SUBJECT: MEETING SUMMARY - STATION BLACKOUT ISSUES
(TAC NO. 40577)

SUBJECT: MEETING SUMMARY - STATION BLACKOUT ISSUES
(TAC NO. 40577)

Draft NUMARC Comments on Proposed SBO Generic Letter

AAC Configuration 2B: Dedicated Diesels with Cross-tie at Multiunit Site

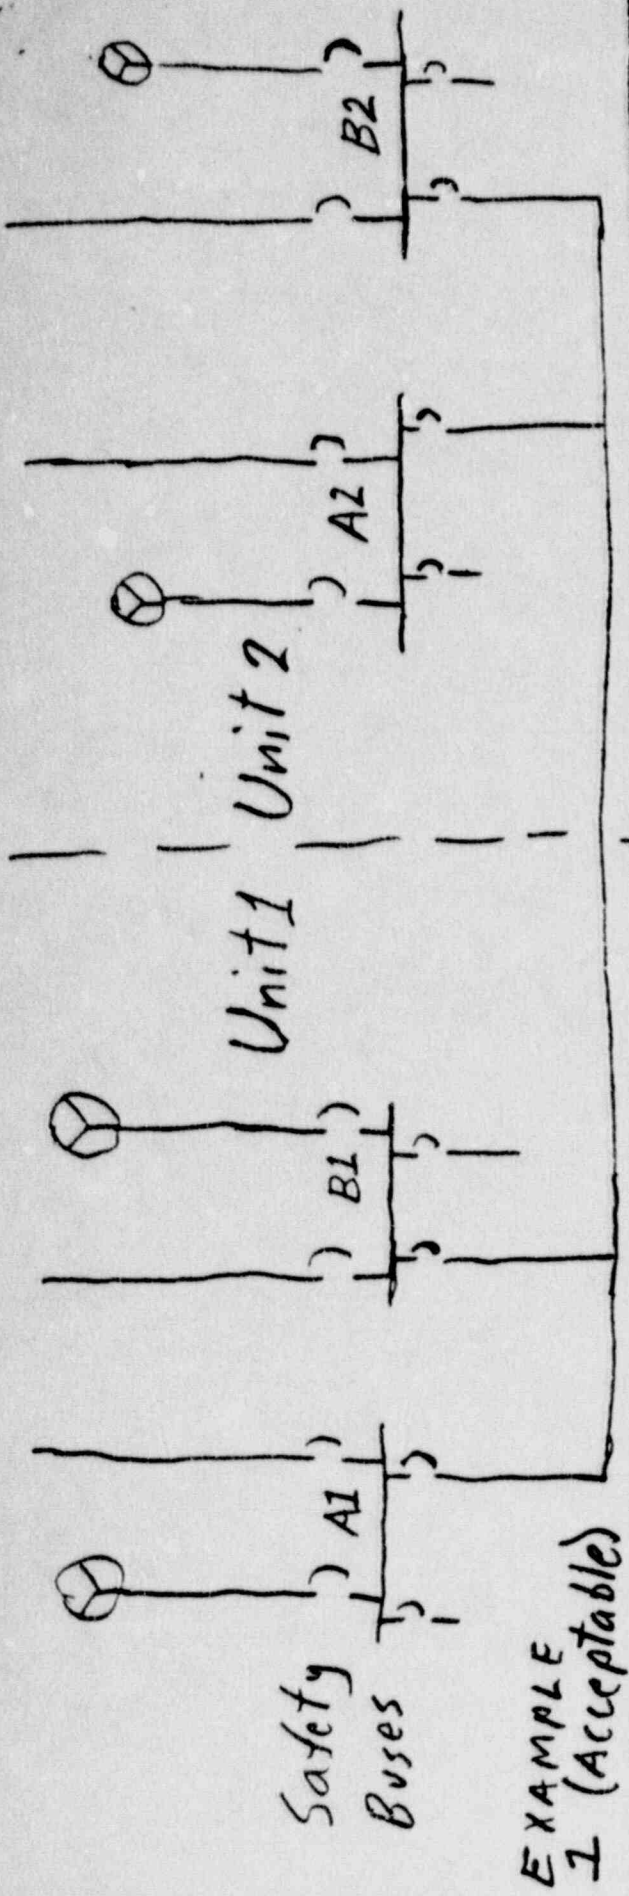
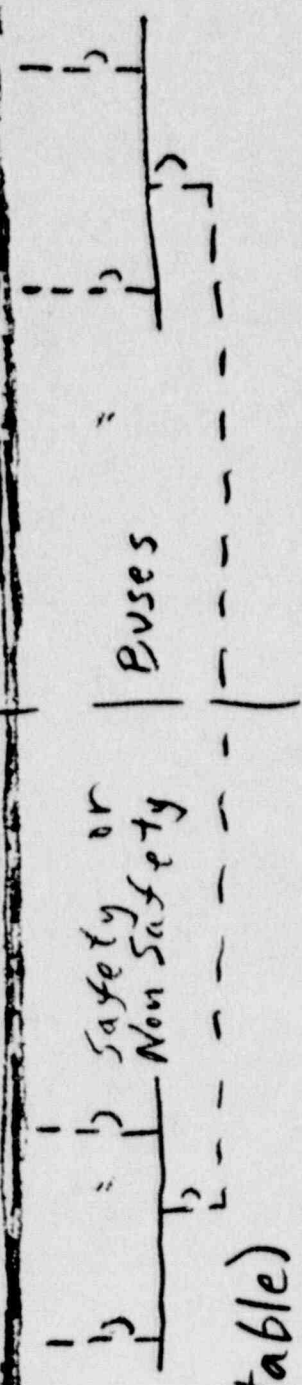
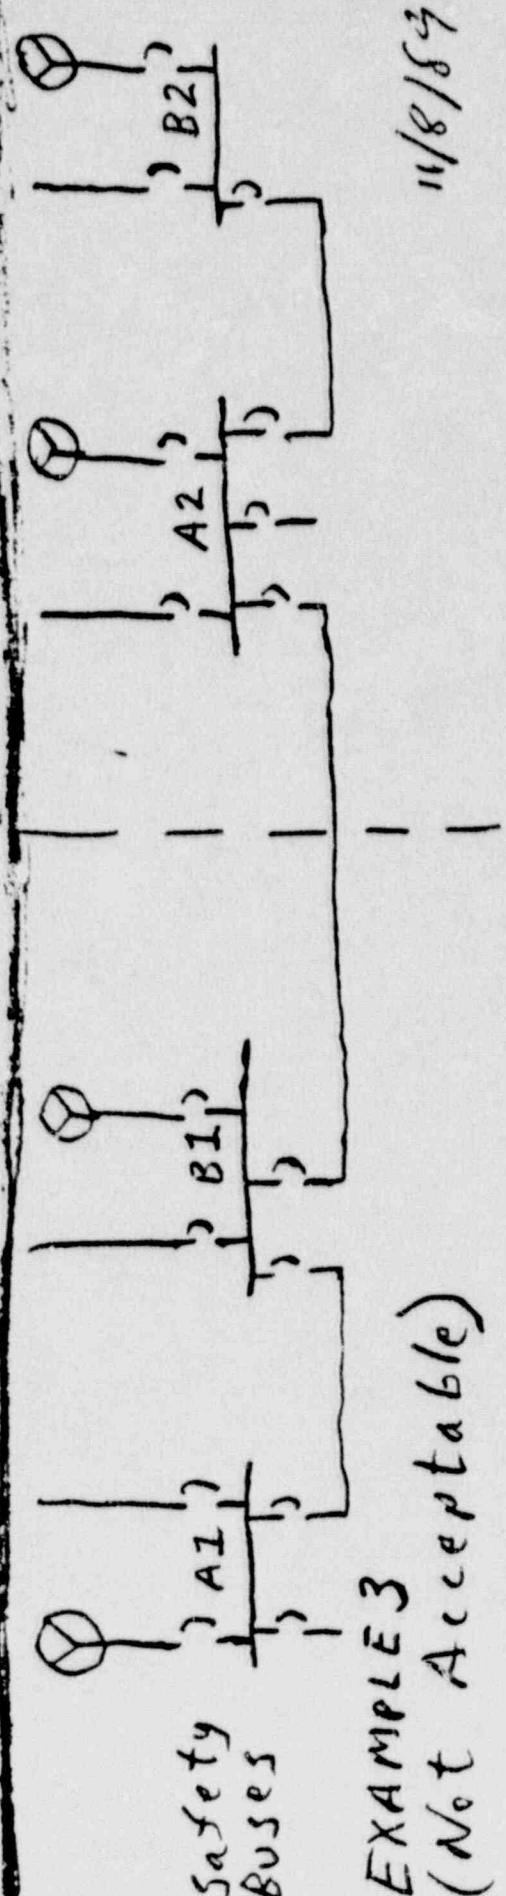
We believe the Staff position that AAC power systems must be designed to withstand an arbitrary single failure is inappropriate and inconsistent with understandings achieved between industry and NRC and reflected in approved SBO guidance.

Concerns relative to the susceptibility of a given AAC configuration to disablement by a single event are adequately addressed by Criterion B.B.e of NUMARC 87-00 which requires that "no single point vulnerability shall exist whereby a likely weather related event or single active failure could disable any portion of the on-site EAC or the preferred power sources and simultaneously fail the AAC power source(s)."

- (e) No single point vulnerability shall exist whereby a likely weather-related event or single active failure could disable any portion of the onsite emergency AC power sources or the preferred power sources, and simultaneously fail the AAC power source(s).
